BROWNFIELD ALLOCATED SITE CONSISTING OF RUBBLE LEFT OVER FROM DEMOLITION. LOCATED IN SPZ 1C. PROPOSALS CONSIST OF RESIDENTIAL, CARE HOME AND DRIVE THROUGH. SCOTTISH AND SOUTHERN ENERGY MARTIN ROAD, HAVANT, HAMPSHIRE PO9 5TH.

Hampshire County Council as Lead Local Flood Authority has provided comments in relation to the above pre-application in our role as statutory consultee on surface water drainage for major developments.

The County Council has reviewed the following documents relating to the above application:

- PRELIMINARY SITE PLAN 9303/100; dated: DECEMBER 2019.

PRELIMINARY SURFACE WATER
DRAINAGE STRATEGY

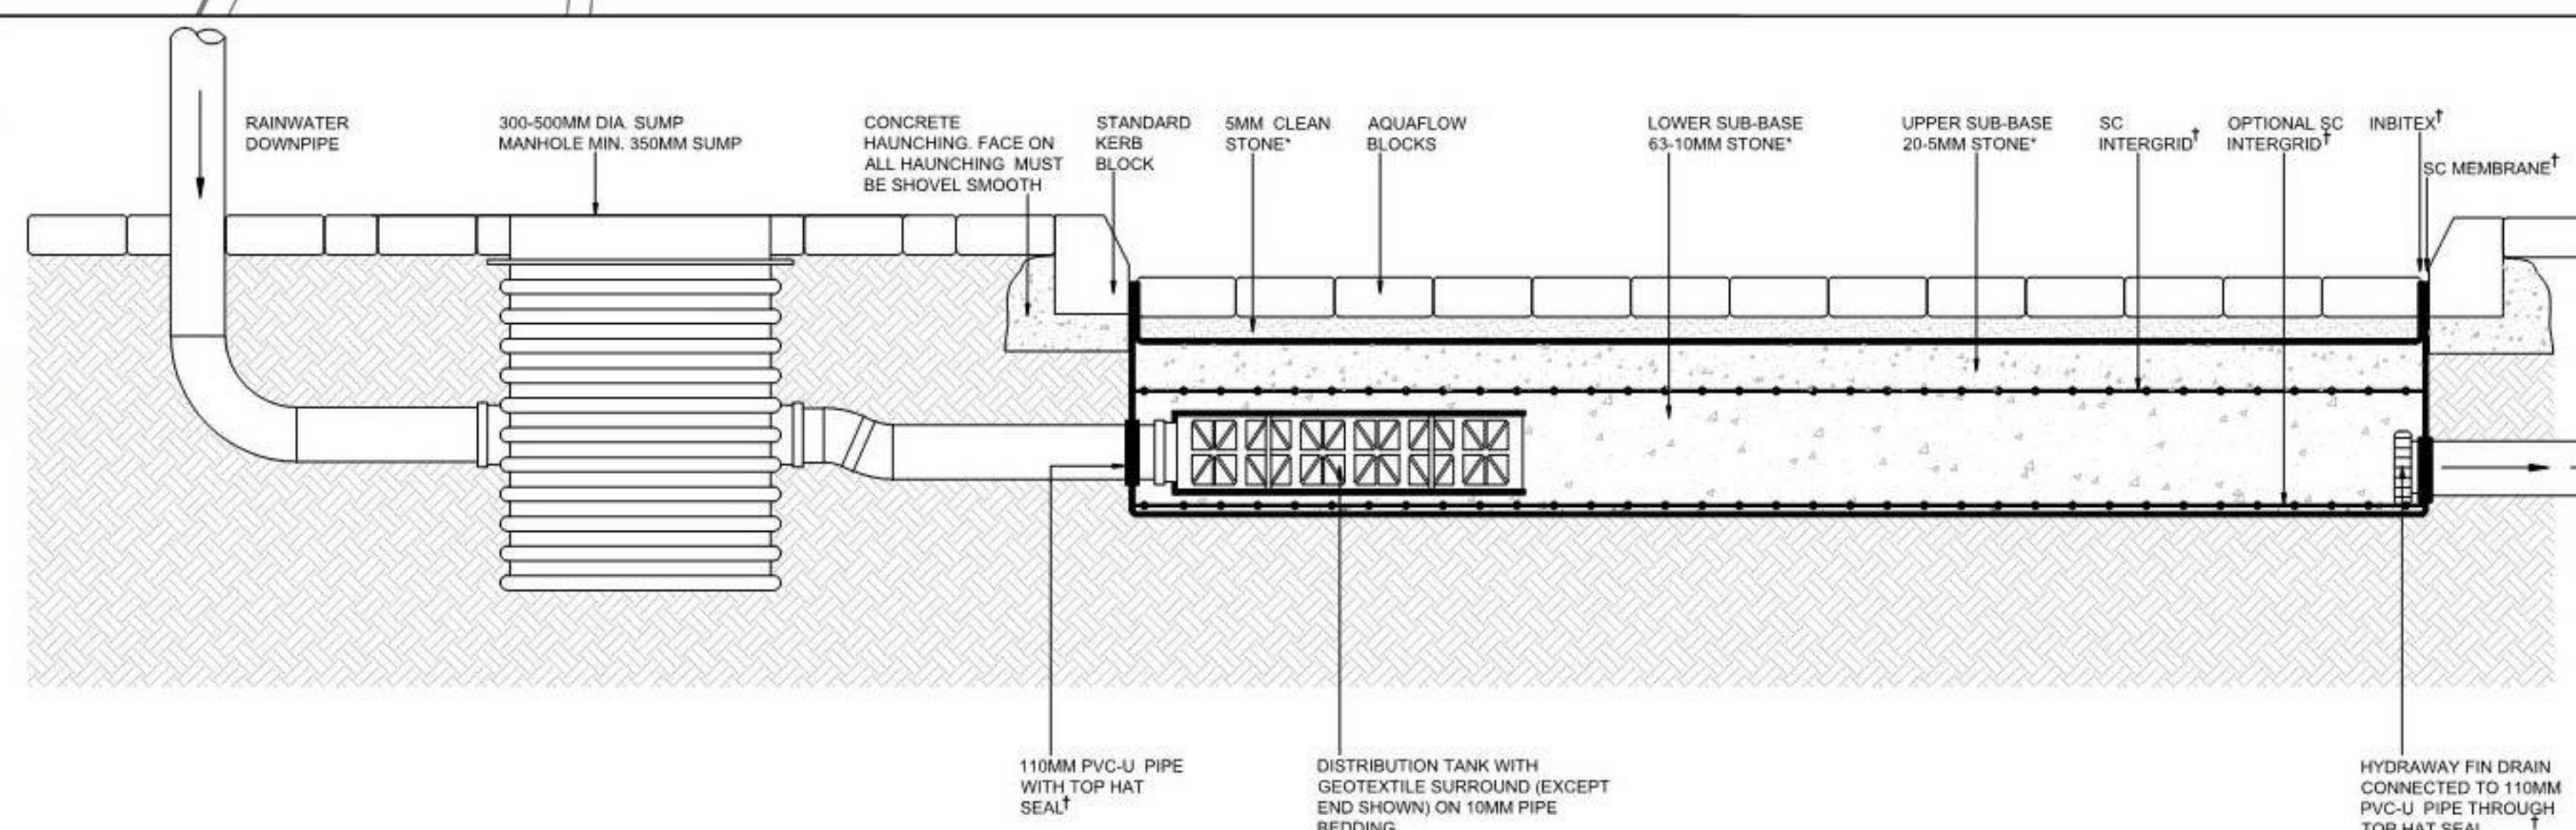
I confirm that keeping site levels on the boundaries where the 1 in 1000 flow path enters the site as close to existing site levels as possible, and then allowing a route through the site safely (proposed arrows), will be sufficient to demonstrate that the existing overland flow route will not be blocked, and to establish that exceedance flow routes within site will be managed safely.

Bearing in mind the existing site characteristics, I also confirm that the 150mm elevation of residential development ground levels will be adequate.

Considering that the infiltration test showed that infiltration is not feasible at the site, and in the absence of any nearby watercourse, we will consider acceptable to discharge surface water runoff to the surface water public sewer network. Bearing in mind that this is a brownfield site, we would also accept a 30% betterment of existing discharge rates. However, since an alternative point of discharge from the application site is not available, we will request agreement from Southern Water for the connection(s) and proposed discharge rate(s) when the application is submitted, as they will have implication in the design detailed drainage system.
